The following is to be read and form part of the contract documents for the above project.

RESPONSES TO QUESTIONS DURING TENDERING

END OF ADDENDUM NO. 2

4) Drawing E1-02-01 vs Drawing E1-03-01

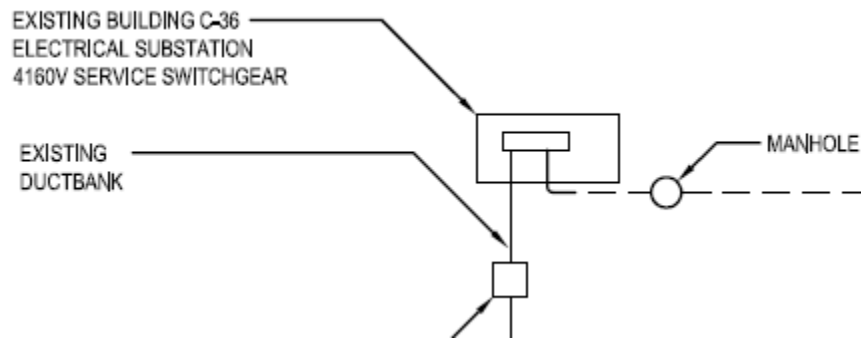
- Detail 12 on E1-02-01 does not match Detail 2 on E1-03-01 ... which duct bank configuration is correct?

- Is the Pull Pit on E1-03-01 required as it is not shown on E1-02-01?

Response: Duct bank configuration shown on E1-02-01 and E3-02-01 is correct. E1-03-01 and E3-03-01 will be revised in future addendum.

Response: Pull pit is not required. Duct bank for C-29/C-30 E-house to be installed in WP02 to a point 3 meters south of the E-house. Final portion to be included in WP03.

7) Drawing E2-02-01 Detail 2

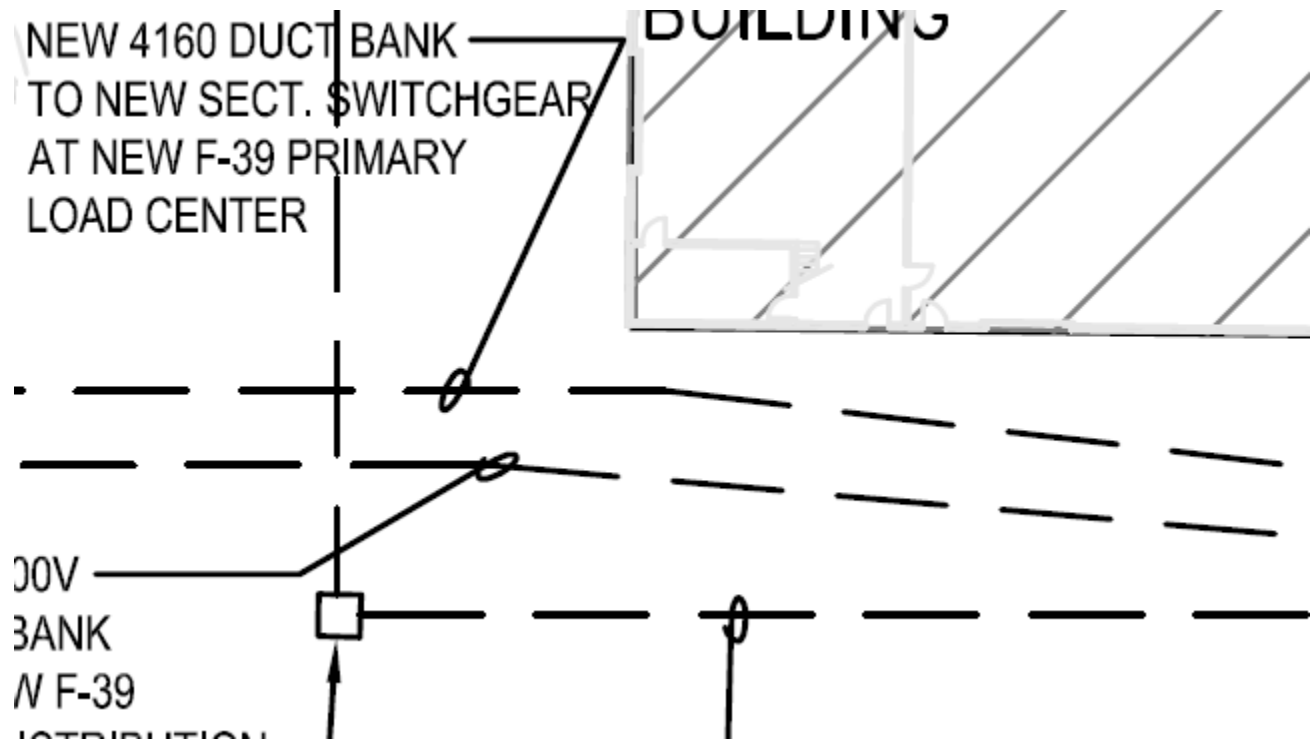
- During the site walk we had concerns with getting an MCC into the penthouse electrical room ... Looking at E7-02-05 there appears to be no motor starters – only overcurrent protection.

- 1) If these are starters ... can loose combo starters, fed from splitter(s), be used in place of an MCC?

Response: Changing loose starters fed from splitter to MCC. MCC to be used. Drawings will be revised in next addendum.

8) Drawing E1-05-01

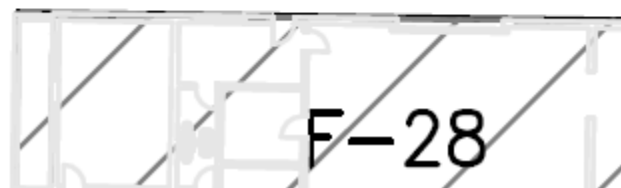
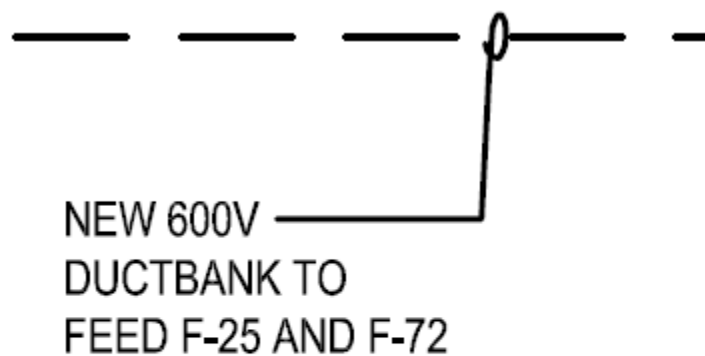
- Despite the note stating 'New 600V Ductbank to Feed F-25 and F-72' I don't see the Ductbank link to F-25. Is this note accurate?

Response: Note is incorrect. Should feed only F-72

1. Revise references to 100mm ducts to 125mm ducts to align with typical duct bank details.
2. Delete text and leader for 'New 600V Ductbank to Feed F-25 and F-72'. Located on duct bank south of building F-28.
